Re: Variance Petition
Oak-Land Middle School Additions Project
Lake Elmo, MN

MEMORANDUM

To: Minnesota State Plumbing Board Date: December 10, 2024
From: Larson Engineering, Inc. Project No: 12246044
Project: Oak-Land Middle School Additions & Renovations
Re: Variance Regarding 2020 Minnesota Plumbing Code Section 310.5

MN

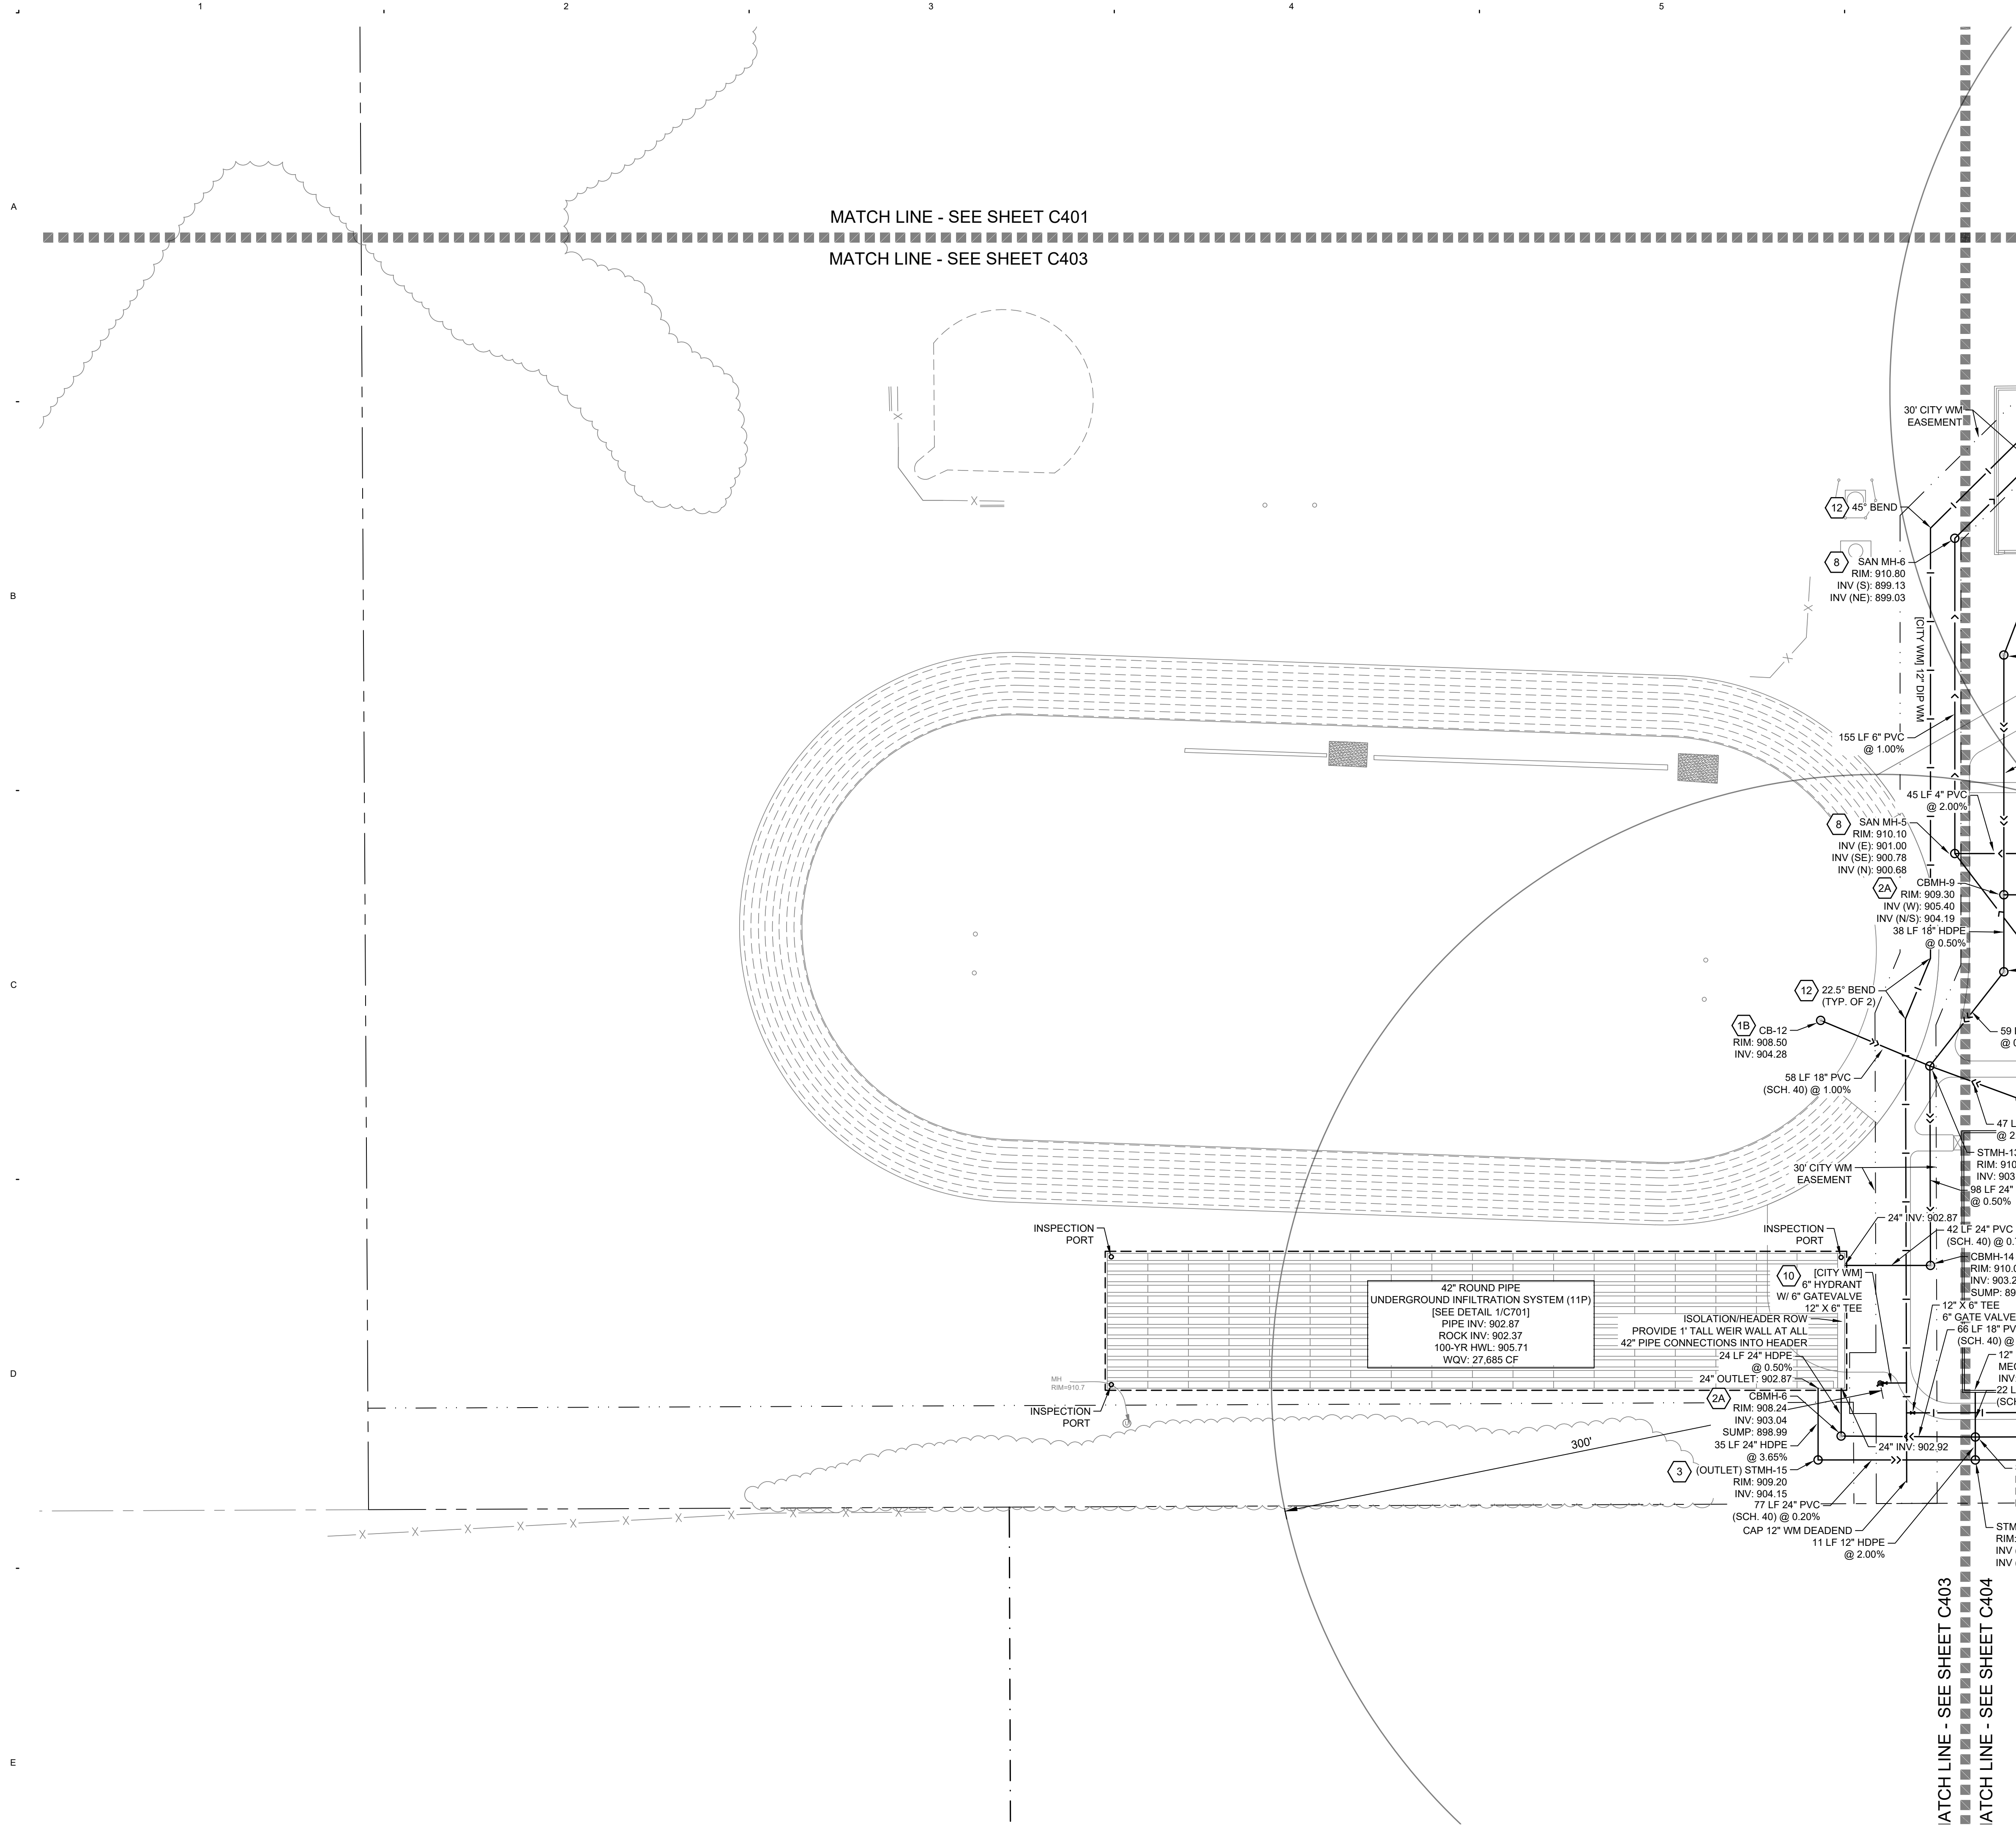
2. Provide a larger site plan showing elevations of the storm system, helps explain why you cannot connect to existing. Show other work that will be completed on the site. **I have attached utility drawings to this email that depict the design if the drywells are maintained, but please note that the stormwater system for the site are rather complex and cluttered. This was initially withheld from the submittal to prevent confusion. The attached plan sheets are not the most recent utility plans for the project as the project is set to start construction this spring and we needed to proceed forward with an alternate design that included a lift station to service the existing roof leader which greatly increased the cost of the civil related work.**
